dsPIC33EPXXGS202 Family Silicon Errata and Data Sheet Clarification

The dsPIC33EPXXGS202 family devices that you have received conform functionally to the current Device Data Sheet (DS70005208C), except for the anomalies described in this document.

The silicon issues discussed in the following pages are for silicon revisions with the Device and Revision IDs listed in [Table 1](#). The silicon issues are summarized in [Table 2](#).

FIGURE 1: TIMING DIAGRAMS FOR CENTER-ALIGNED AND EDGE-ALIGNED MODES

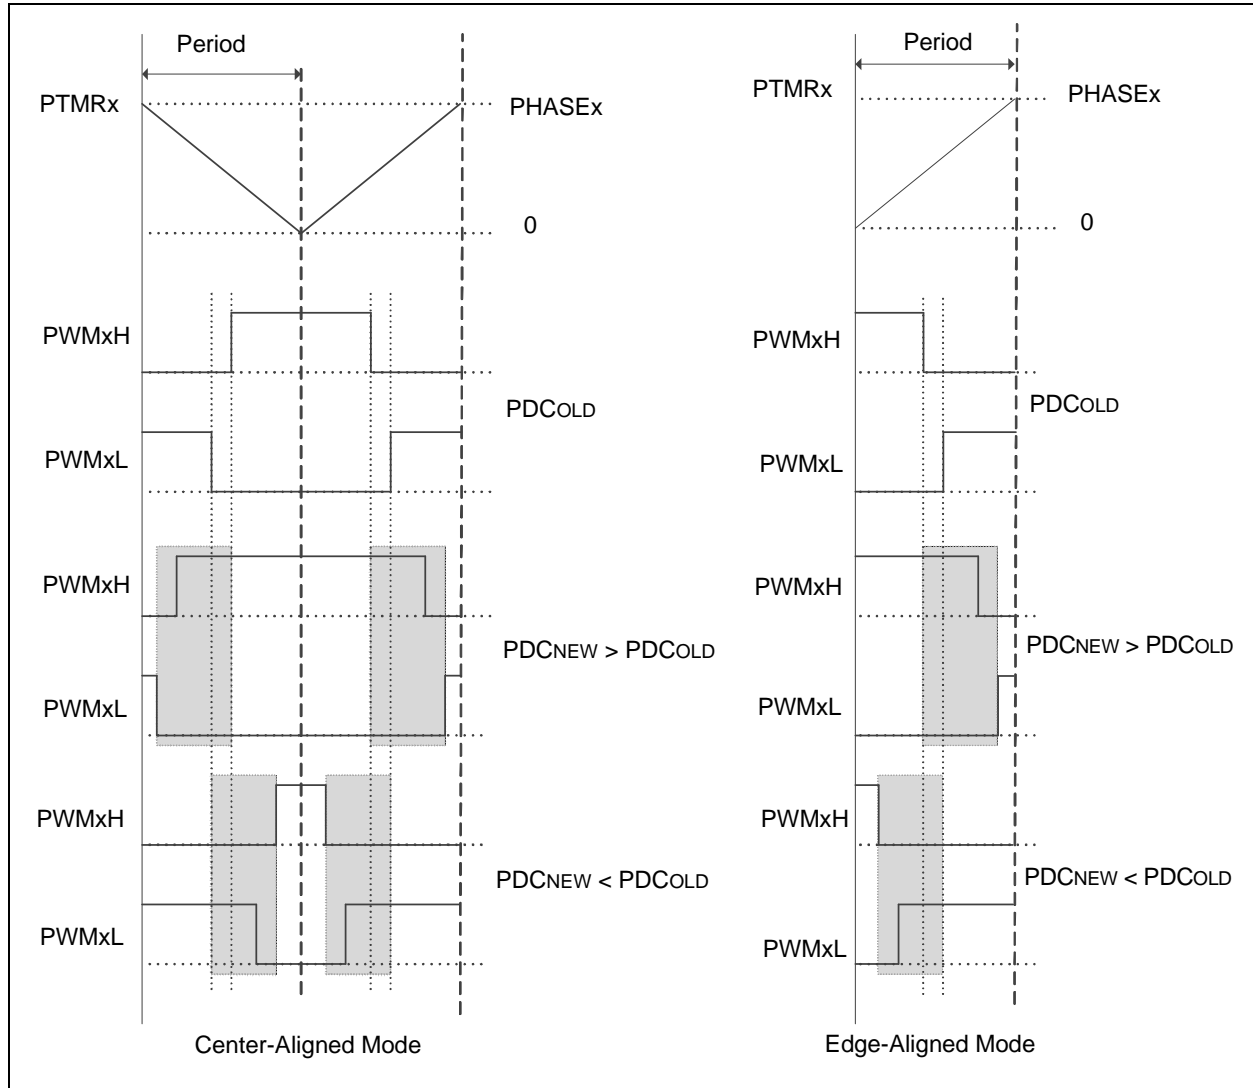
The PWMx generator may not assert dead time on the edges of transitions. This has been observed when all of the following conditions are present:

- The PWMx generator is configured to operate in Complementary mode with the independent time base or master time base
- Immediate update is enabled
- The value in the PDCx register is updated in such a manner that the PWMxH and PWMxL outputs make an immediate transition

The current duty cycle, PDCOLD, newly calculated duty cycle, PDCNEW, and the point at which the write to the Duty Cycle register occurs within the PWMx time base, will determine if the PWMxH and PWMxL outputs make an immediate transition. PWMxH and PWMxL outputs make an immediate transition if the Duty Cycle register is written with a new value, PDCNEW, at a point of time when the PWMx time base is counting a value that is in between PDCNEW and PDCOLD. Additionally, writing to the Duty Cycle register close to the instant of time where dead time is being applied may result in reduced dead time, effective on the PWMxH and PWMxL transition edges.

In [Figure 1](#), if the duty cycle write occurred in the shaded box, then PWMxH and PWMxL will make an immediate transition without dead time.

None. However, in most applications, the duty cycle update timing can be controlled using the TRIGx trigger or Special Event Trigger to avoid the above mentioned conditions.

FIGURE 2: EXAMPLE FOR REDUNDANT OUTPUT MODE

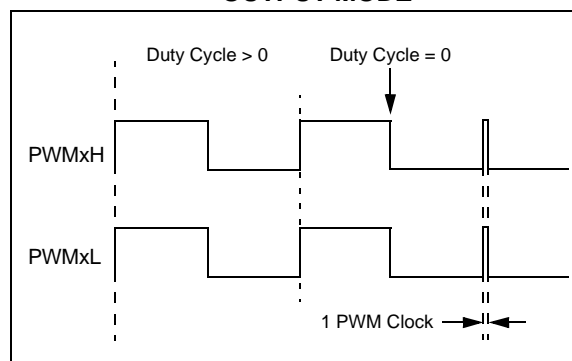
In the Redundant Output mode (IOCONx<11:10> = 0b01) and Push-Pull Output mode (IOCONx<11:10> = 0b10), with the Immediate Update Enable bit disabled (PWMCONx<0> = 0), when the Duty Cycle register is updated from a non-zero value to zero, a glitch pulse of a width equal to 1 PWM clock will appear at the next PWM period boundary, as shown in Figure 2 (for the Redundant Output mode). The Duty Cycle register refers to the PDCx register if PWMCONx<8> = 0 or the MDC register if PWMCONx<8> = 1.

If the application requires a zero duty cycle output, there are two possible work around methods:

1. Use the PWM override feature to override the PWM output to a low state instead of writing to the Duty Cycle register. In order to switch back to a non-zero duty cycle output, turn off the PWM override. The override-on and override-off events must be timed close to the PWM period boundary if the IOCONx register has been configured with IOCONx<0> = 0 (i.e., output overrides through the OVDDAT<1:0> bits occur on the next CPU clock boundary).
2. Enable the Immediate Update Enable bit (PWMCONx<0> = 1) while configuring the PWMx module (i.e., before enabling the PWMx module, PTCON<15> = 1). With the Immediate Update enabled, writes to the Duty Cycle register can have an immediate effect on the PWM output. Therefore, the duty cycle write operations must be timed close to the PWM period boundary in order to avoid distortions in the PWM output.

FIGURE 3:

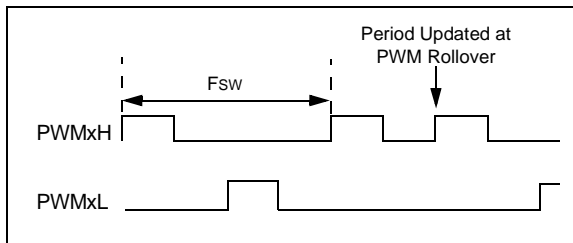
When the PWM module is configured for Push-Pull mode (IOCONx<11:10> = 0b10) with the Enable Immediate Period Update bit enabled (PTCON<10> = 1), a write to the Period register that coincides with the period rollover event may cause the push-pull output logic to produce back-to-back pulses on the PWMx pins (Figure 3).

If the EIPU bit is set (PTCON<10> = 1), ensure that the update to the PWM Period register occurs away from the PWM rollover event. Use either the PWM Special Event Trigger (SEVTCMP) or the PWM Primary Trigger (TRIGx) to generate a PWM Interrupt Service Routine (ISR) near the start of the PWM cycle. The PWM Period register could be updated inside this ISR so that the period writes do not occur near the PWM period rollover event.

FIGURE 4: MISMATCH OF WORKING REGISTER SET WHEN NESTING MORE THAN ONE INTERRUPT WITHIN INTERRUPTS THAT USE ALTERNATE WORKING REGISTER SETS

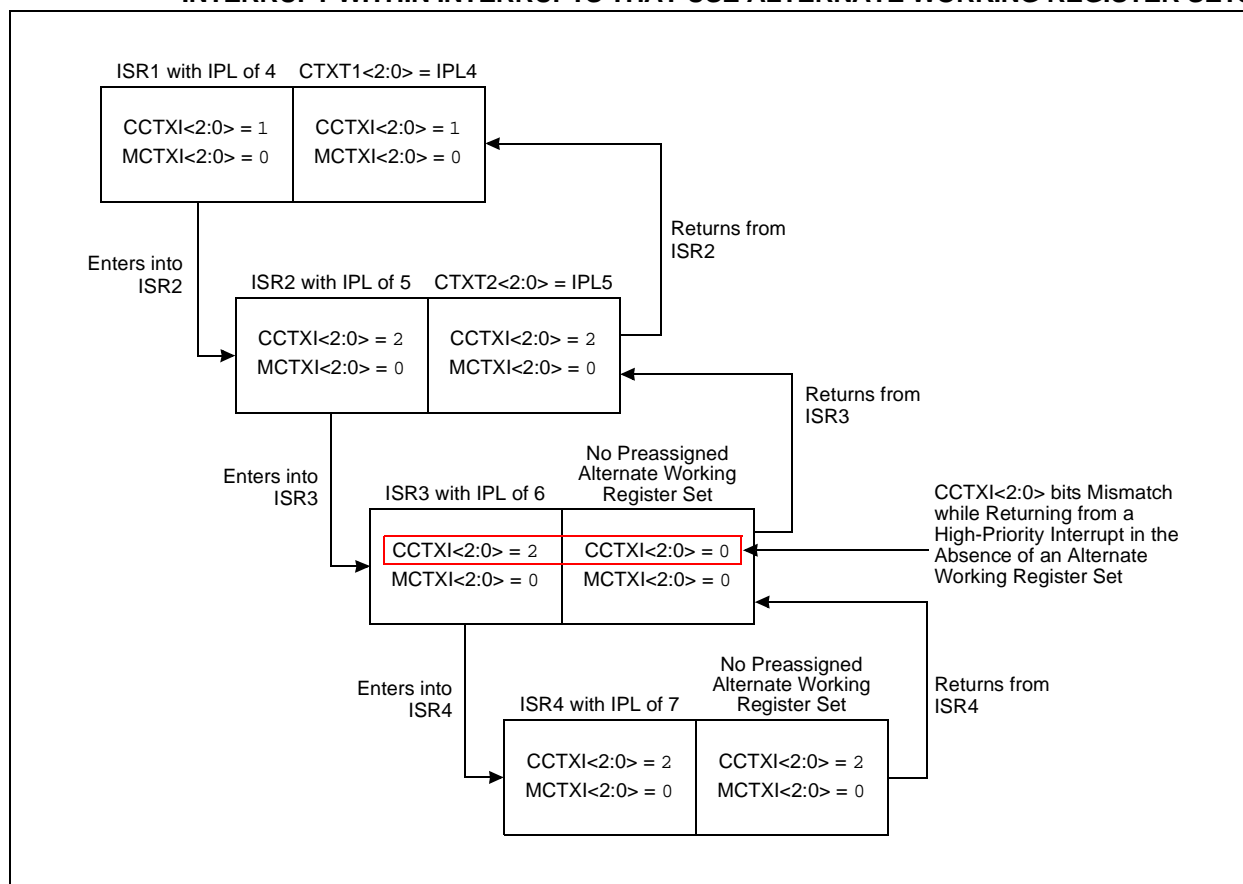
When returning from an Interrupt Service Routine (ISR) by executing the `RETFIE` instruction, in the case of a nested interrupt, the Interrupt Priority bits (`IPC<3:0>`) associated with the lower priority interrupt are compared with the `CTXTn` bits field in the `FLTREG` Configuration register:

- If there is a match with either of the `CTXTn` bits field, then the corresponding Alternate Working Register Set is chosen and the Current Context Identifier bits (`CCTXI<2:0>`) in the `CTXTSTAT` register are updated to reflect the new Alternate Working Register Set.
- If there is no match with either of the `CTXTn` bits field, then the expected behavior is to keep the context (defined by the value of the Current Context Identifier bits, `CCTXI<2:0>` in the `CTXTSTAT` register) unchanged. However, the

context gets changed. A new context corresponding to the value in the Manual Context Identifier bits (`MCTXI<2:0>`) in the `CTXTSTAT` register is selected by the hardware and the `CCTXI<2:0>` bits in the `CTXTSTAT` register are modified to reflect this change.

When using interrupts with the Alternate Working Register Set (automatic context assignment), no more than one ISR without an Alternate Working Register Set must be nested within an ISR with an Alternate Working Register Set.

Issue and work around are illustrated in [Figure 4](#) and [Figure 5](#), respectively. The figures show the status bits, `CCTXI<2:0>` and `MCTXI<2:0>`, after entering into an ISR from a lower priority ISR (left pane), and after returning to the same ISR from a higher priority ISR (right pane).
